RHODE ISLAND CONTRACT No. 2017-CB-053

Rehabilitation of Silver Creek Bridge No. 153

NOTICE TO PROSPECTIVE BIDDERS

ADDENDUM NO. 2 Prospective bidders and all concerned are hereby notified of the following changes in the Plans, Specifications, Proposal and Distribution of Quantities for this contract. These changes shall be incorporated in the Plans, Specifications, Proposal and Distribution of Quantities, and shall become an integral part of the Contract Documents.

FED. ROAD DIV. NO.	STATE	FEDERAL AID PROJECT NO.	FISCAL YEAR	SHEET NO.	TOTAL SHEETS
	RI	BHO-0153(002)	2019	23A	41

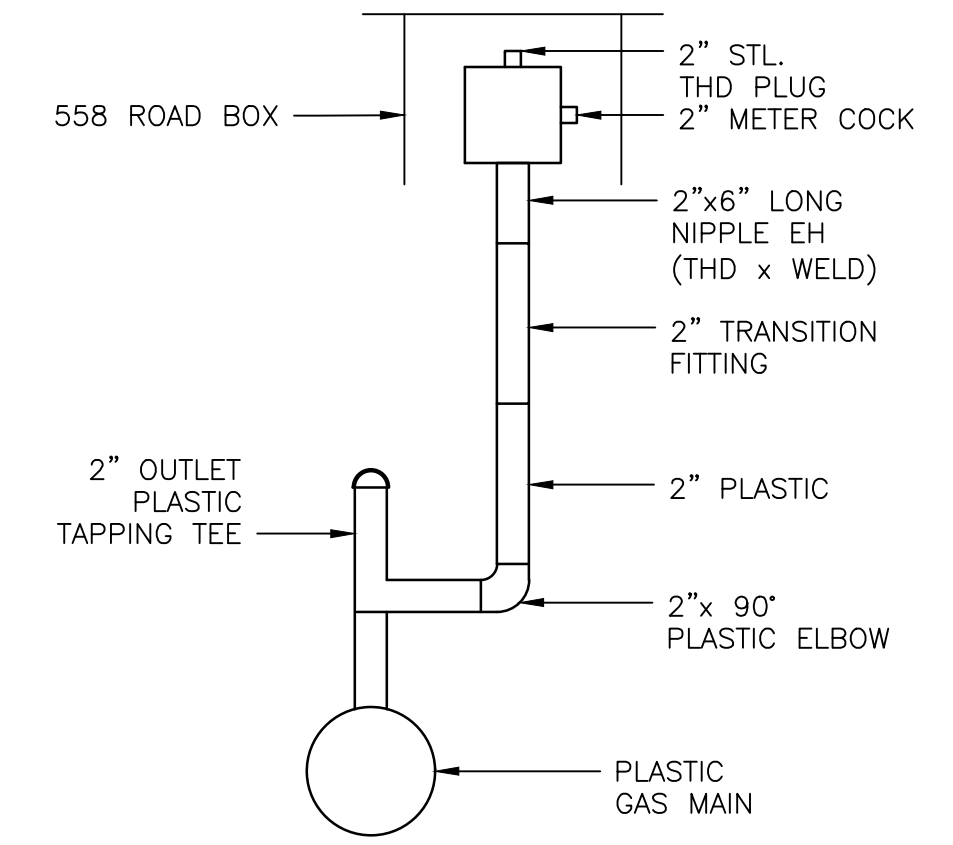
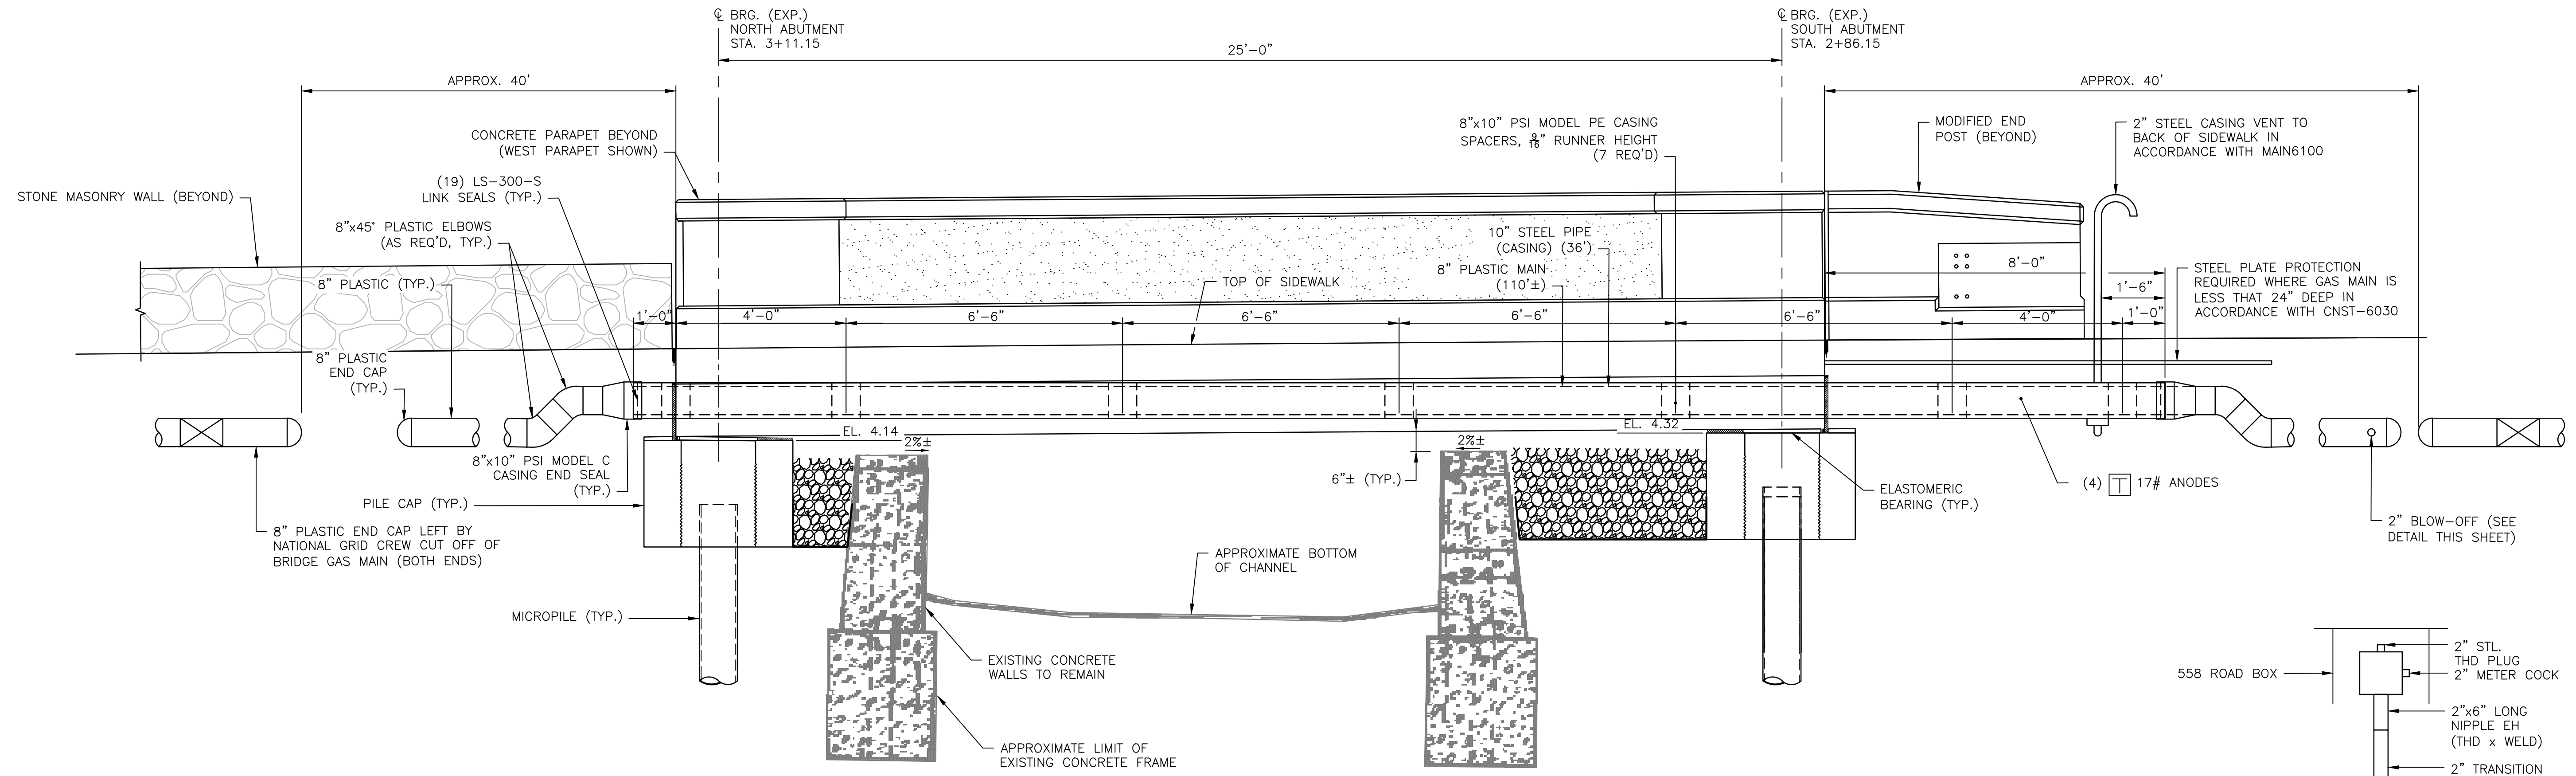
7. Add Plan Sheet 23A attached to this Addendum #2 to the plan set. The sheet was added to show the alignment and details of the proposed gas main replacement.

**PILE LAYOUT PLAN
AND DETAILS**

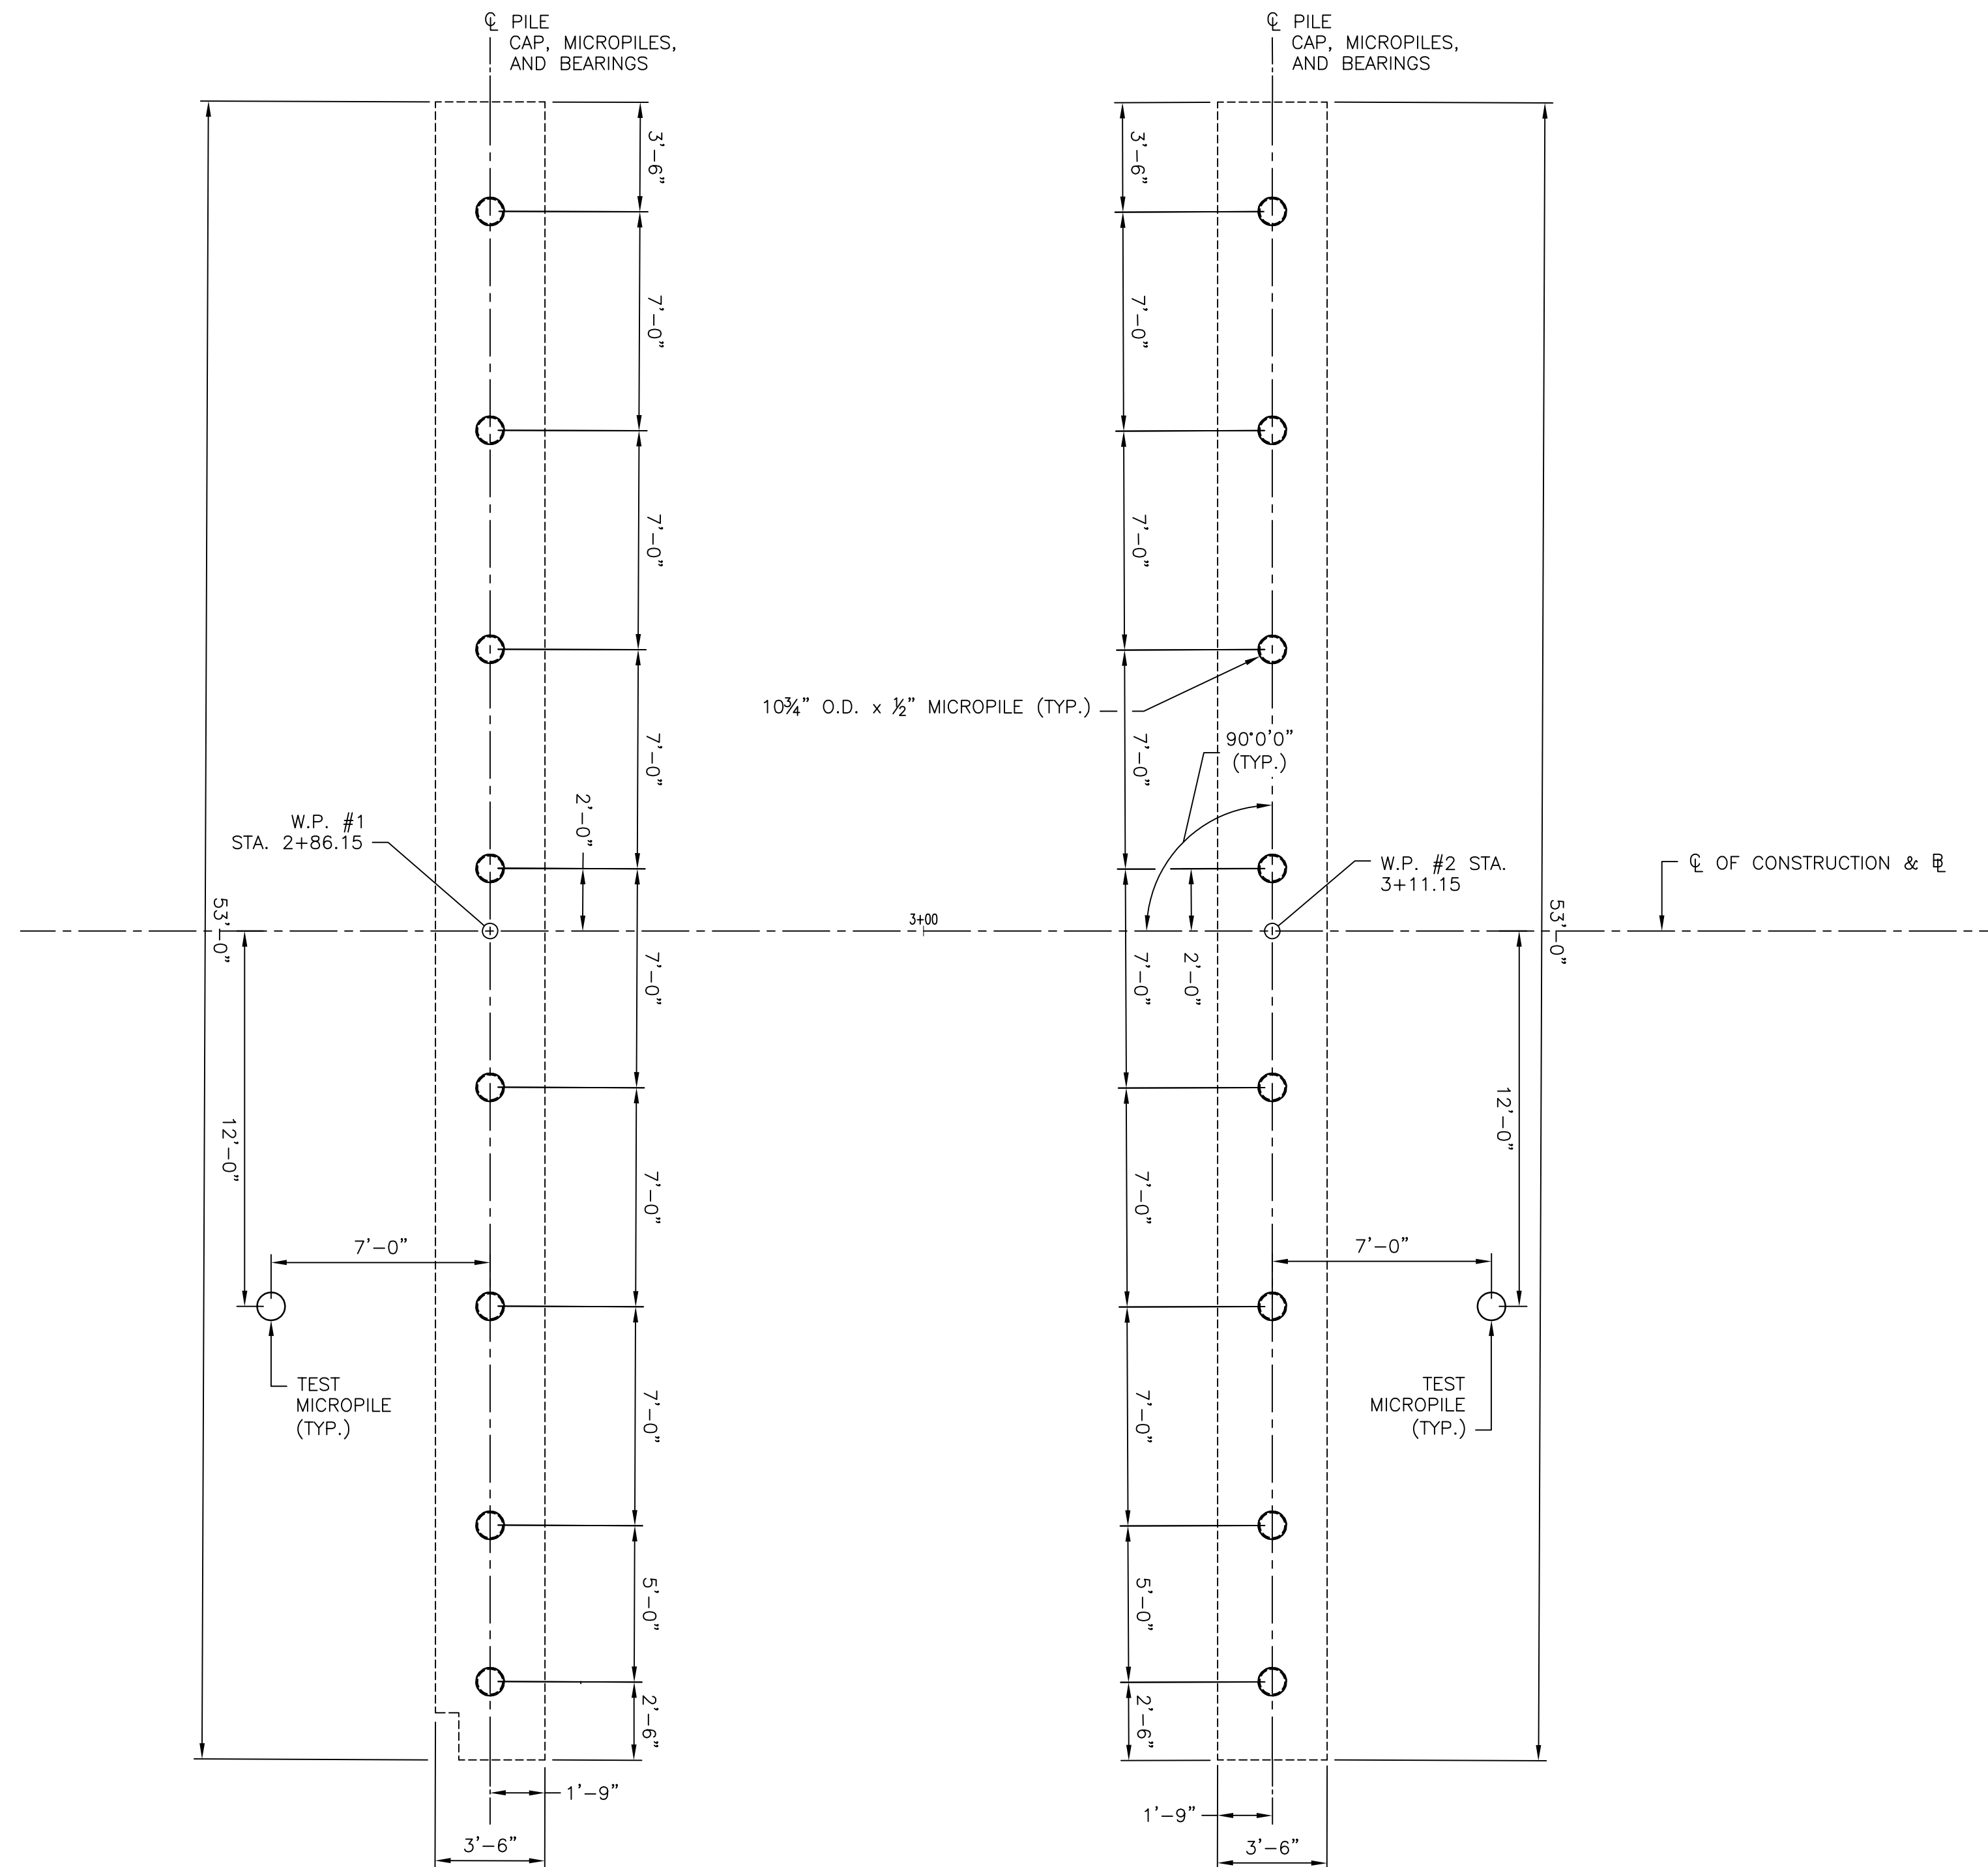
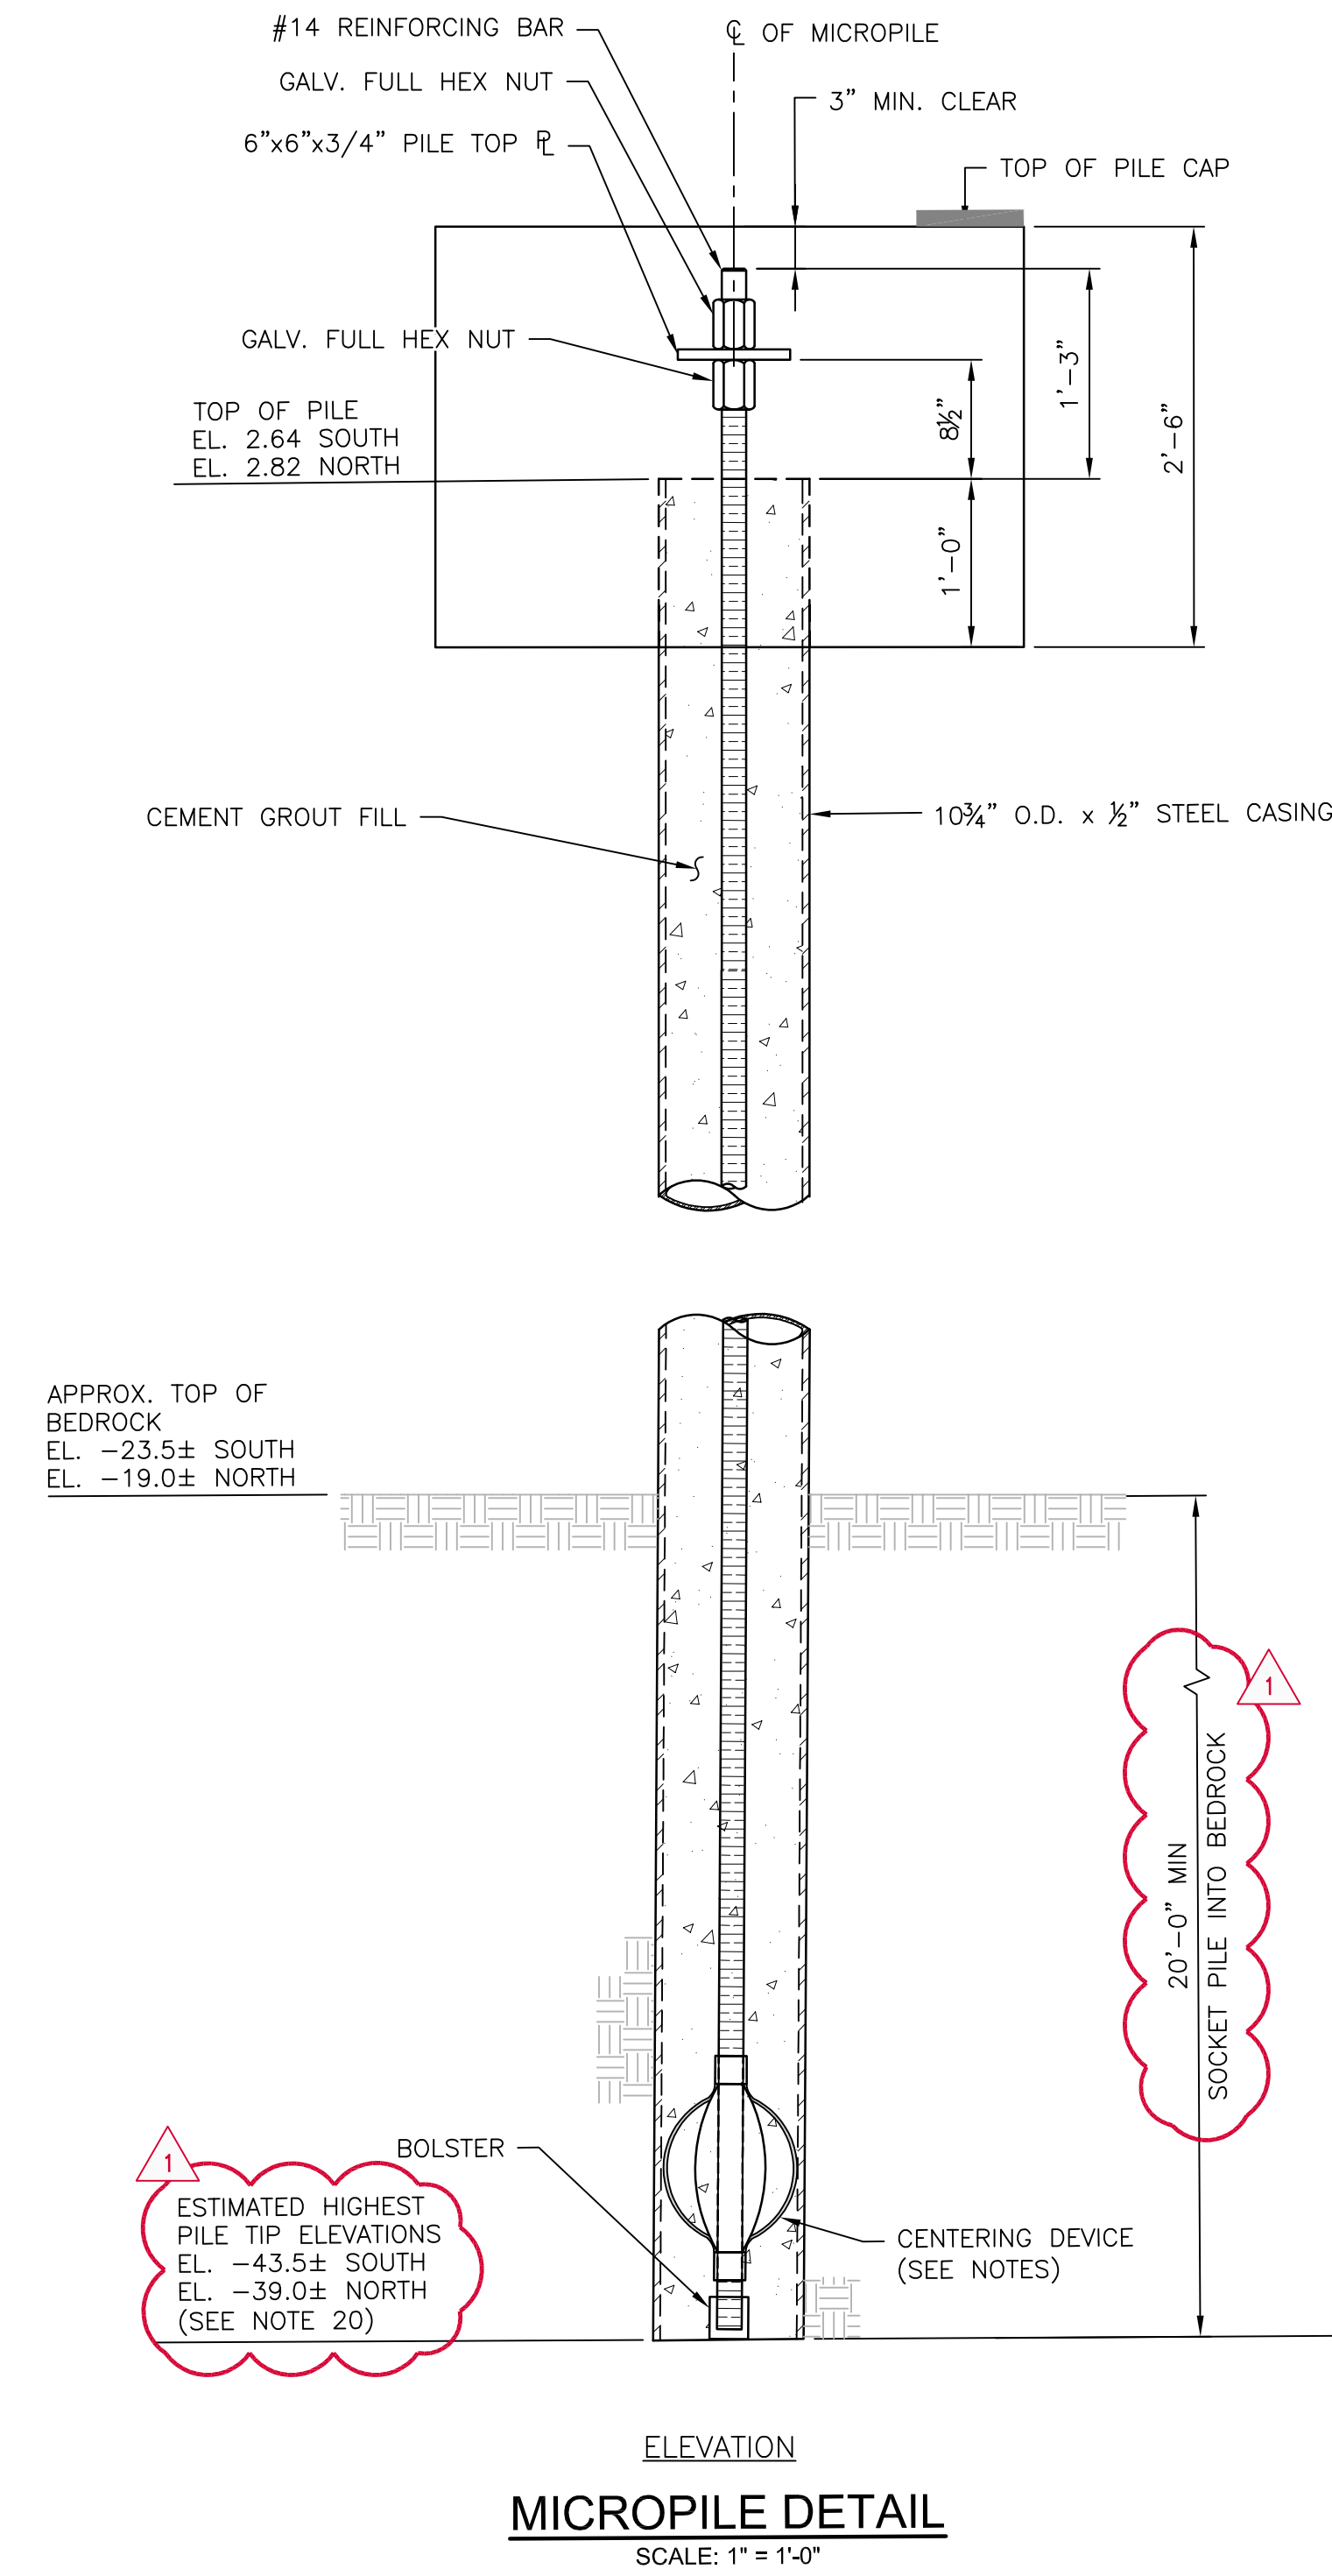
8. Replace Plan Sheet 24 with Sheet 24(R-1) attached to this Addendum #2. The estimated pile tip elevation have been revised.
9. Replace Plan Sheet 25 with sheet 25(R-1) attached to this Addendum #2. The gas main casing has been revised to 10" diameter, and the Elevation and Section Thru Abutment have been revised to indicate cast-in-place pile caps.
10. Replace Plan Sheet 39 with Sheet 39(R-1) attached to this Addendum #2. A detail has been added to show the limits of removal of the existing abutments to place the casings for the sewer and water mains.
11. Replace Plan Sheet 40 with Sheet 40(R-1) attached to this Addendum #2. The groundwater elevations on the boring logs have been revised.

Are the Pile Caps Cast in Place or Precast? Section thru abutment detail on Sheet 25 calls out CLSM Type II and Leveling blocks under the pile cap. Please Clarify.
